## INSTRUCTION – REINFORCING GUSSET ON HEADER FRAME LEG A-SERIES AUGER HEADER

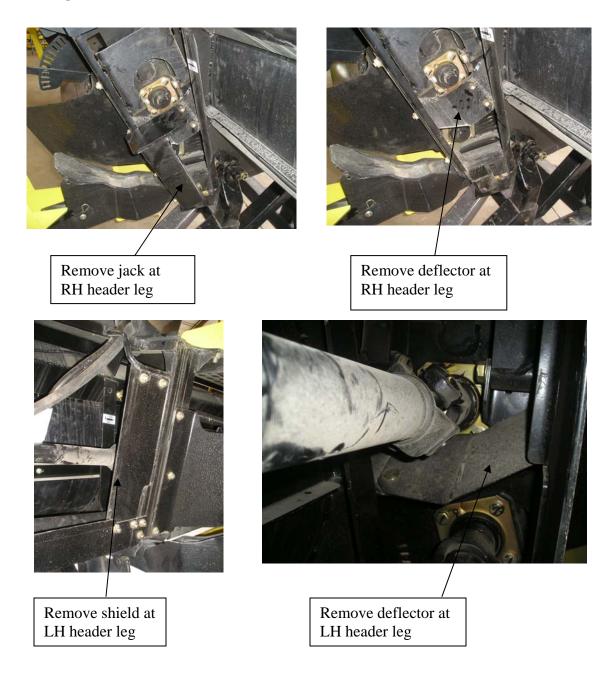
To reinforce A-Series Auger Header frame legs and prevent fatigue cracks at the lower conditioner roll mounts on the header leg, weld gussets 170373 qty 1 at both Header legs as follows:

Position gusset on header leg and weld along highlighted lines. Weld all around inside of hole in gusset. Note: Gusset at RH leg is shown. (similar at LH header leg).

Install defectors at LH and RH header leg. Install shield at LH header leg and Jack at RH header leg.
